PROJECT NO. 54335

REVIEW OF MARKET REFORM §
ASSESSMENT PRODUCED BY § PUBLIC UTILITY COMMISSION OF
ENERGY AND § TEXAS
ENVIRONMENTAL ECONOMICS, §
INC. (E3)

RESPONSES OF CITY OF GEORGETOWN TO COMMISSION QUESTIONS

Figure 43. Potential PCM Supply and Demand ('Base' and 'Steep') Curves

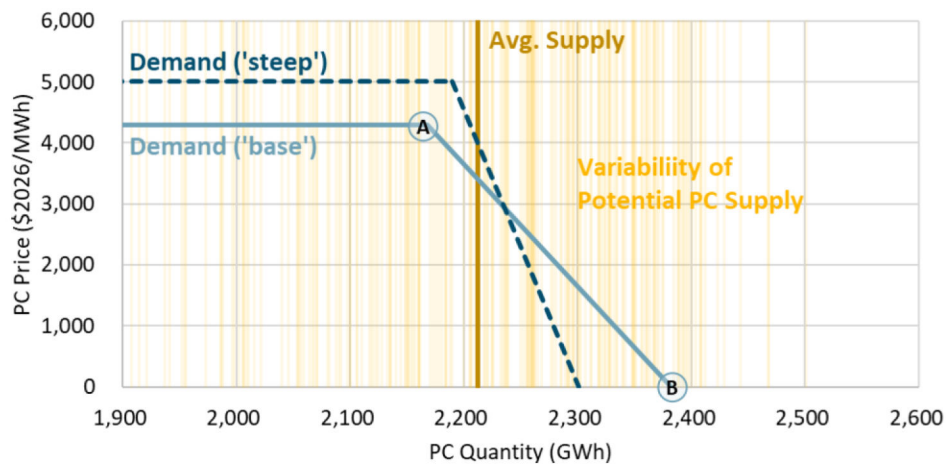
2. **The PCM design will result in highly uncertain PC values from year to year which is likely to not result in the desired investment in new generation.** Since PC prices are determined by the PC Demand Curve based on ERCOT's forecast of total PC generation for the next year that is used to value actual PC generation, this will result in highly unpredictable and almost random PC prices that are not tied to the ERCOT system meeting the reliability standard set by the Commission. PC prices could be \$0 even when the system does not meet the reliability standard and PC prices could be at the cap when the system far exceeds the reliability standard. The graph in page 106 of the E3 report illustrates this uncertainty in PC prices based on variability of PC supply:

This uncertainty and randomness of PC prices from year to year will not incentivize new dispatchable resource investment.

Figure 43. Potential PCM Supply and Demand ('Base' and 'Steep') Curves

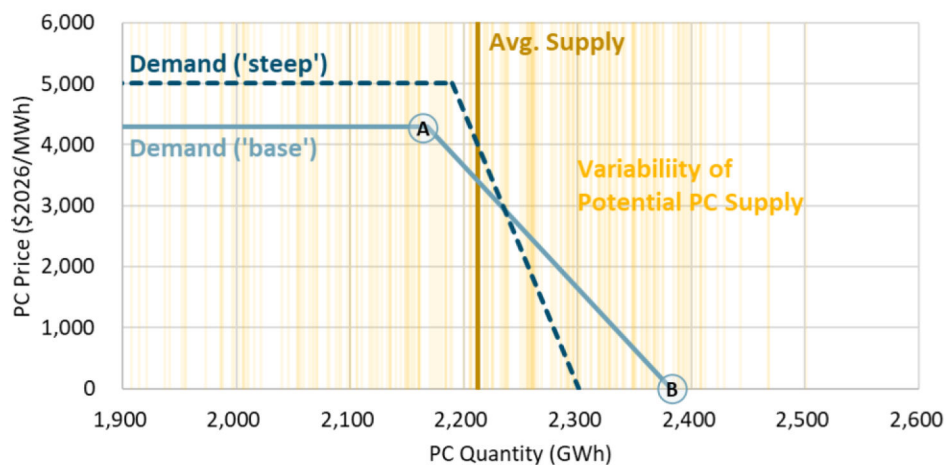
2. **The PCM design will result in highly uncertain PC values from year to year which is likely to not result in the desired investment in new generation.** Since PC prices are determined by the PC Demand Curve based on ERCOT's forecast of total PC generation for the next year that is used to value actual PC generation, this will result in highly unpredictable and almost random PC prices that are not tied to the ERCOT system meeting the reliability standard set by the Commission. The graph in page 106 of the E3 report illustrates this uncertainty in PC prices based on variability of PC supply:

This uncertainty and randomness of PC prices from year to year will not incentivize new dispatchable resource investment.
